**DOCUMENT 00 90 00
ADDENDUM**

ADDENDUM NO. [1] Date: February 25, 2021

**RE: ARCADIA SCHOOL DISTRICT
DAYCARE FACILITY REMODEL
350 EAST RIVER ST
ARCADIA, WI 54612
HSR PROJECT NO. 20016**

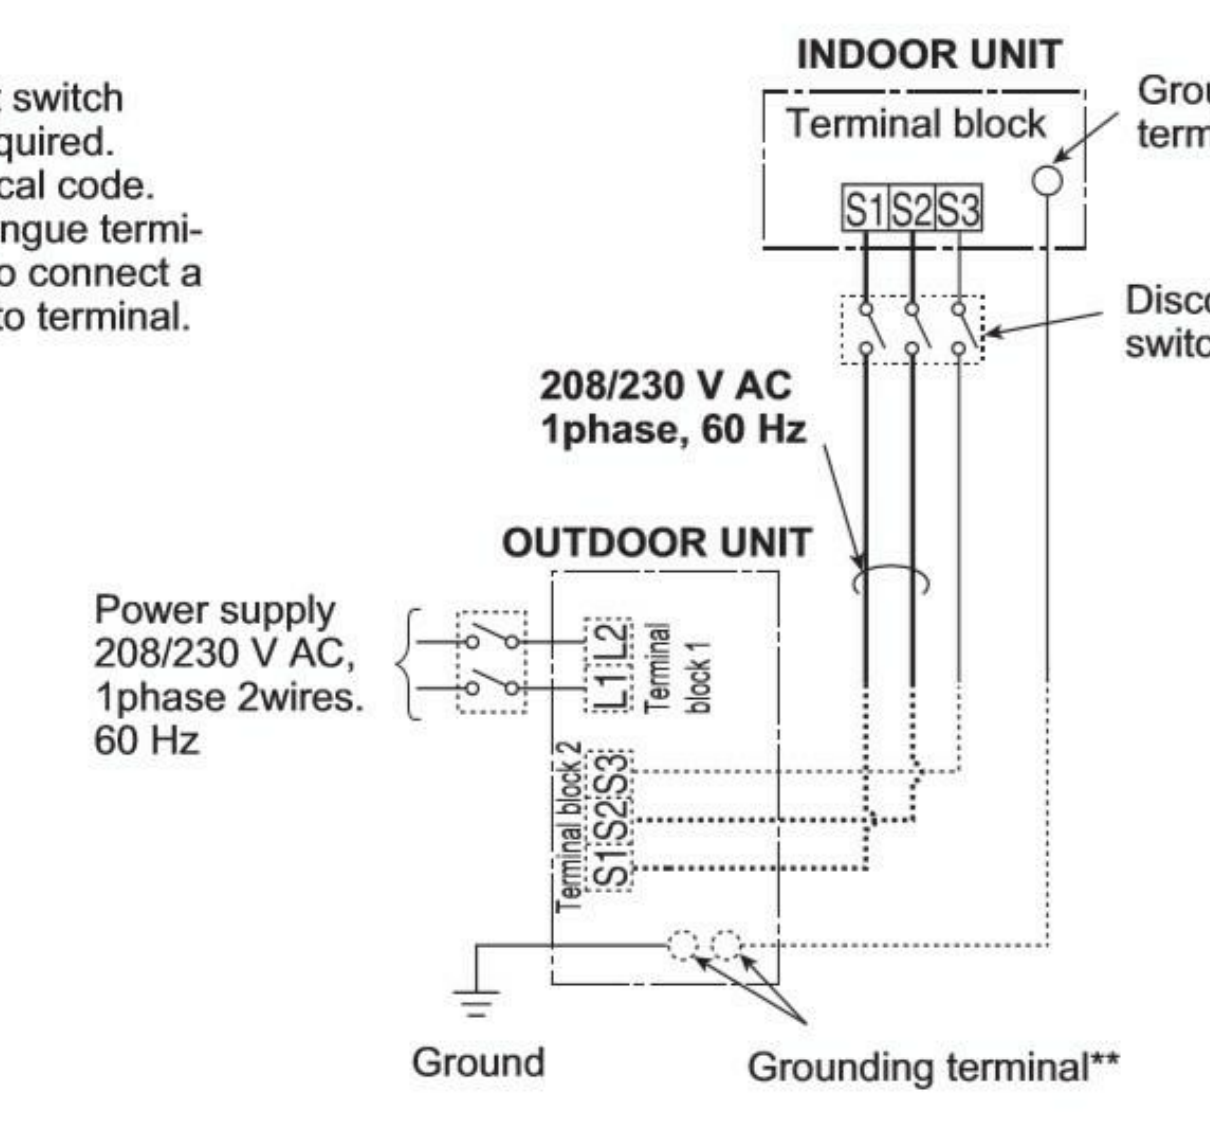
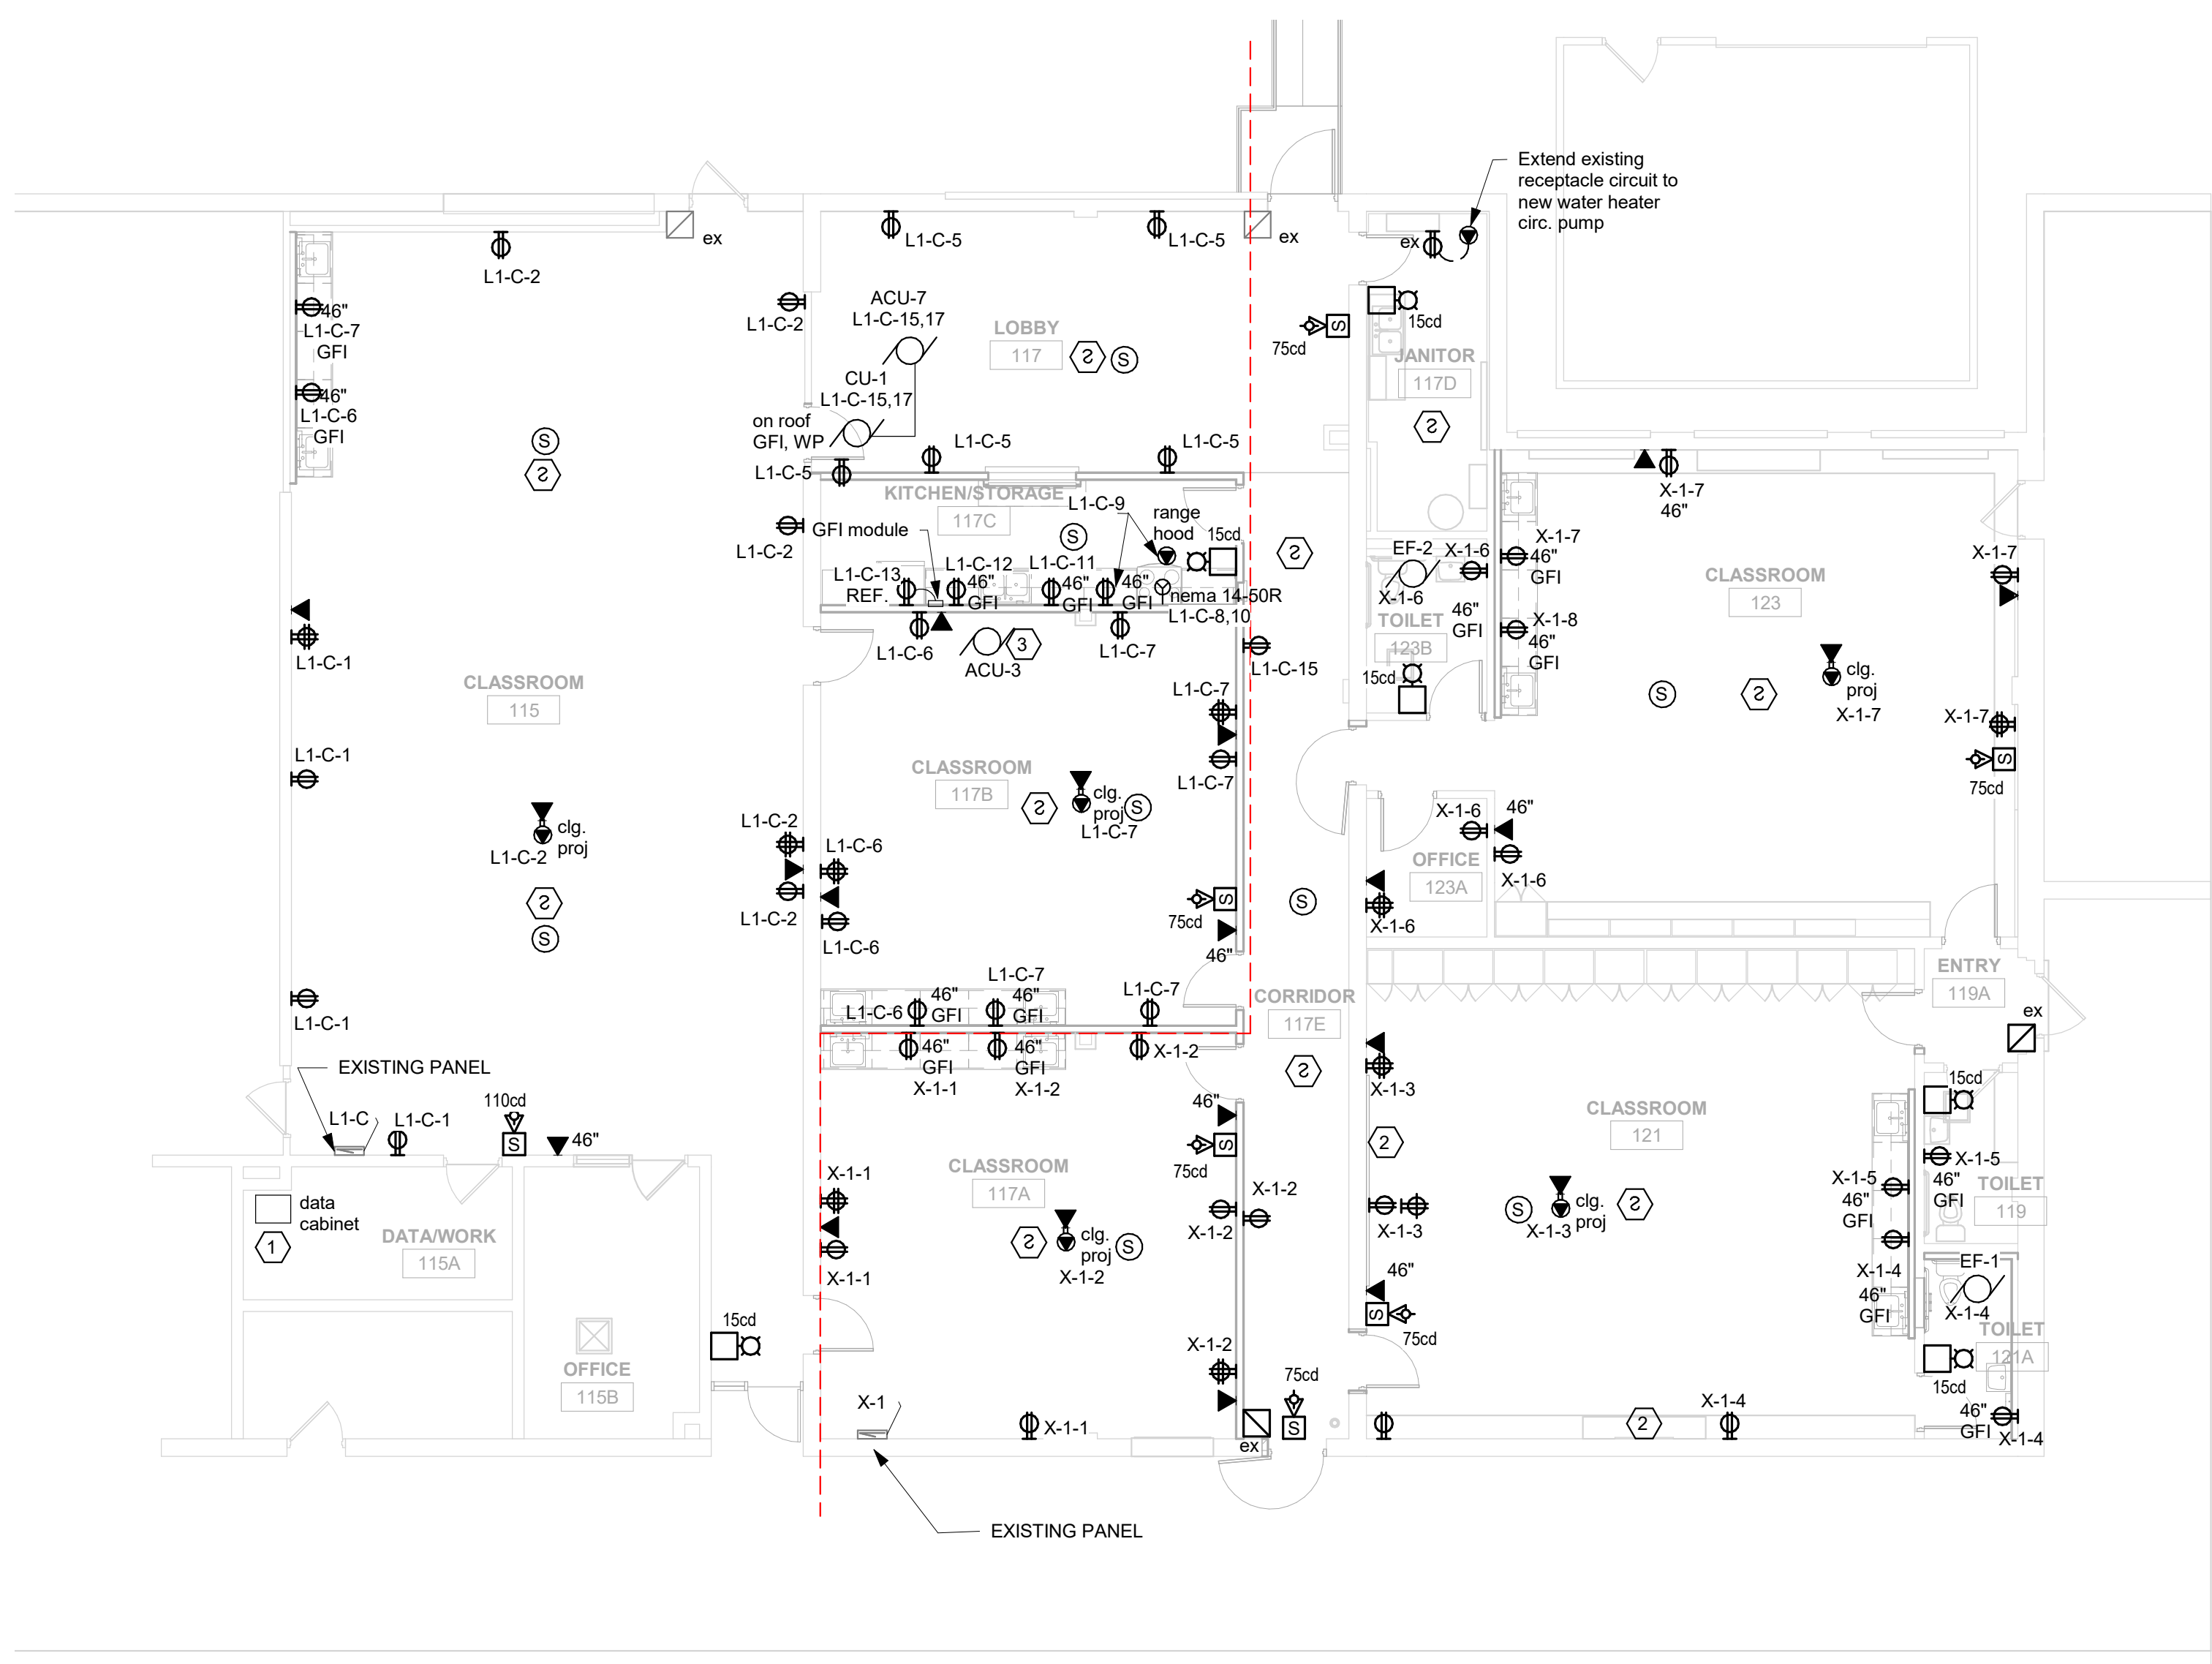
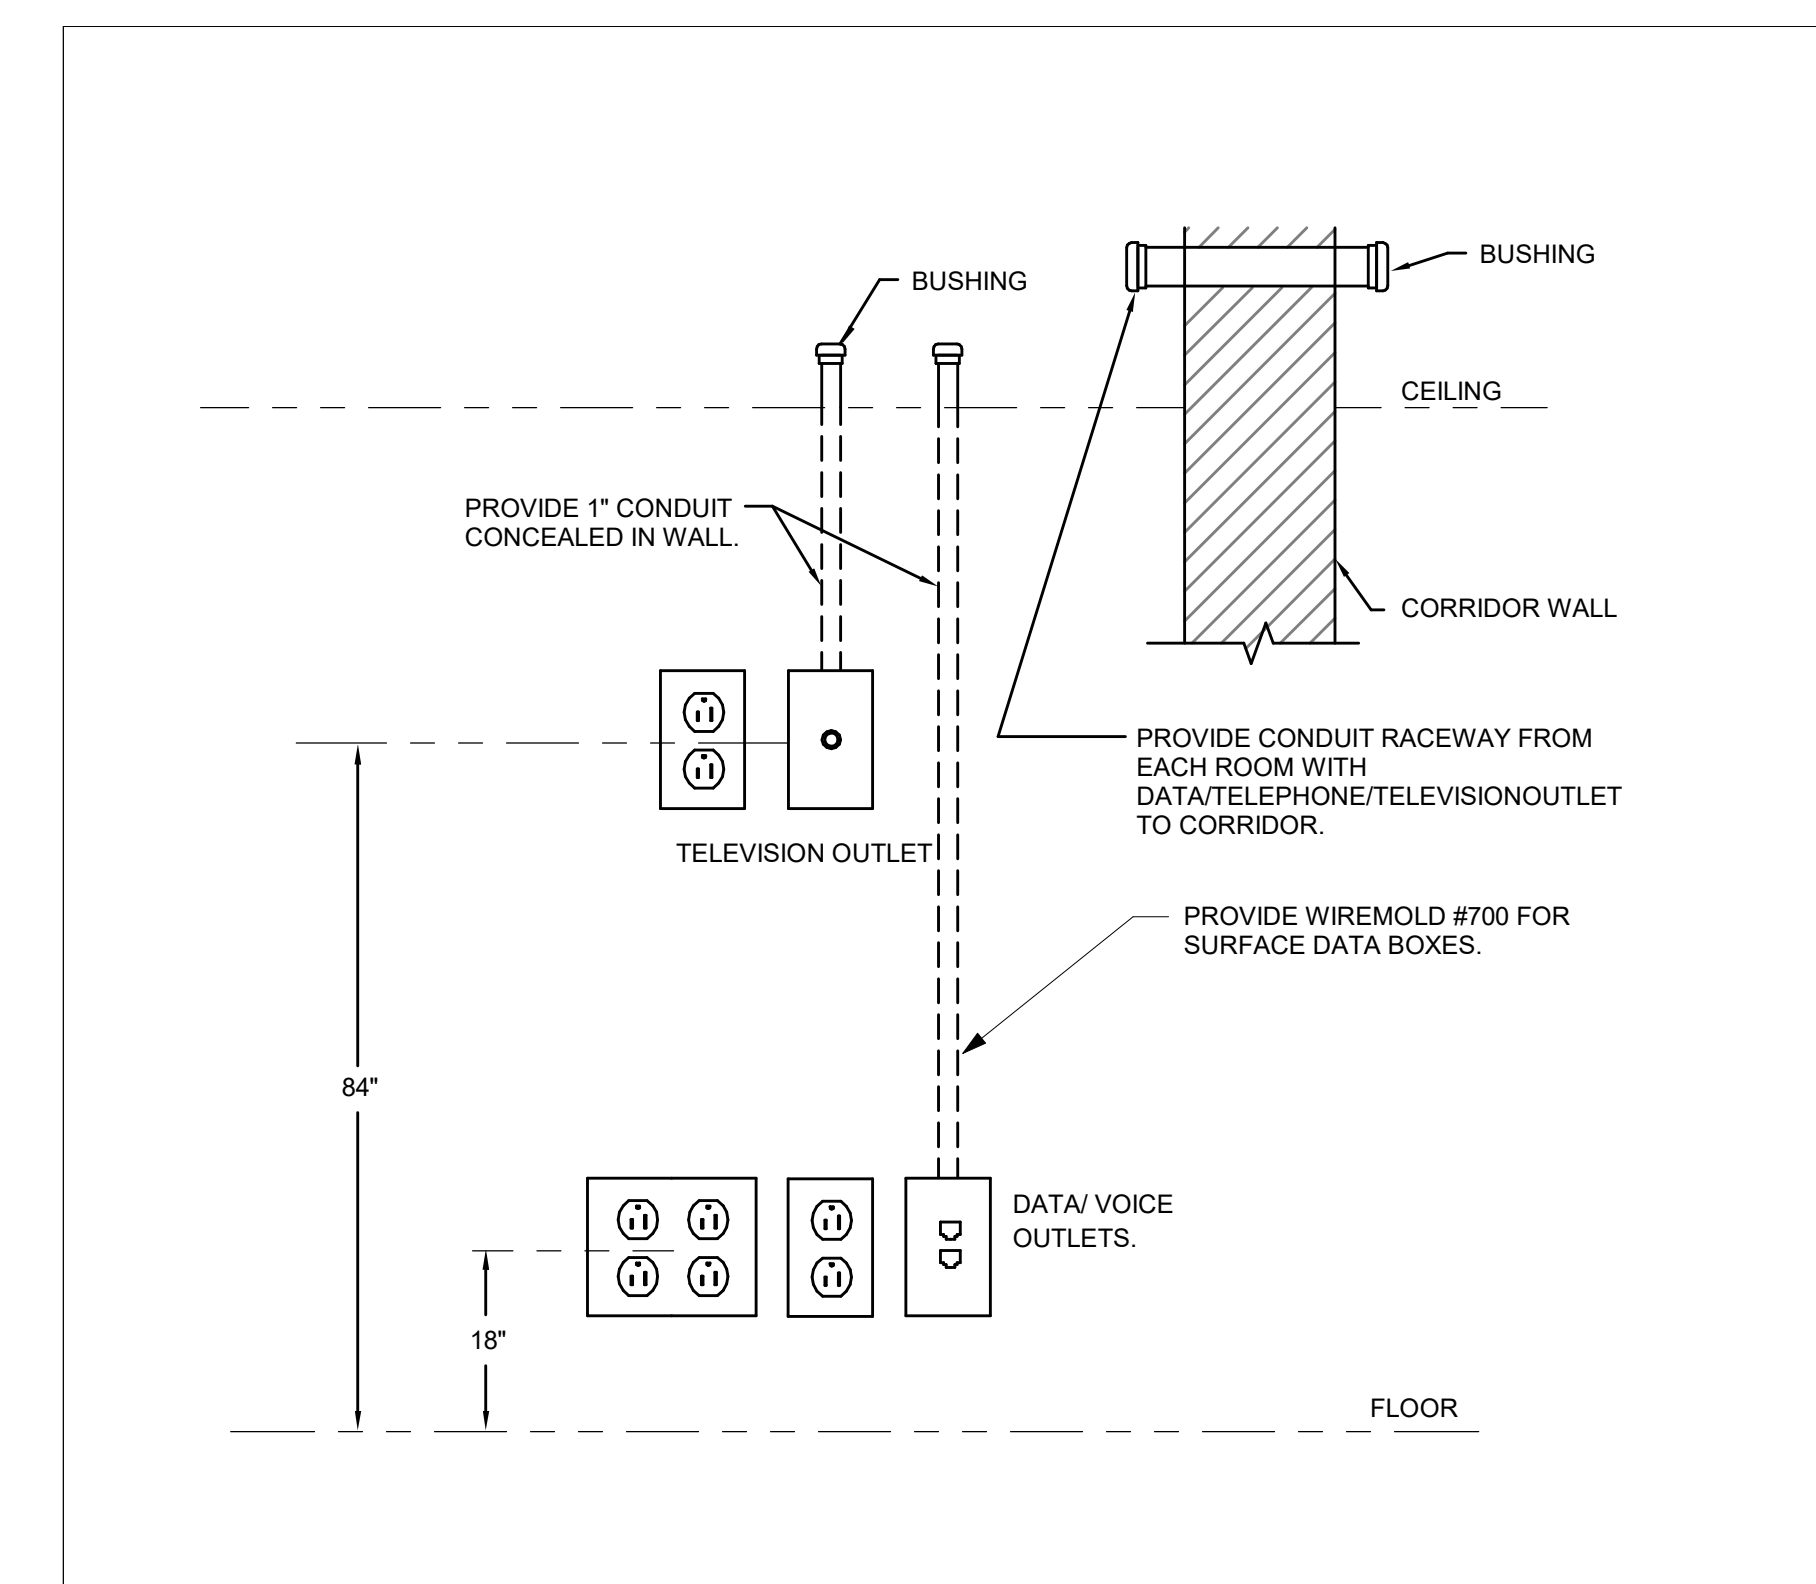
2. Sheet E200 POWER PLAN 30 x 42 attached hereto
 - a. Revisions clouded on Drawing.
 - b. Add Panelboard Schedule.
 - c. Add Motor Schedule.
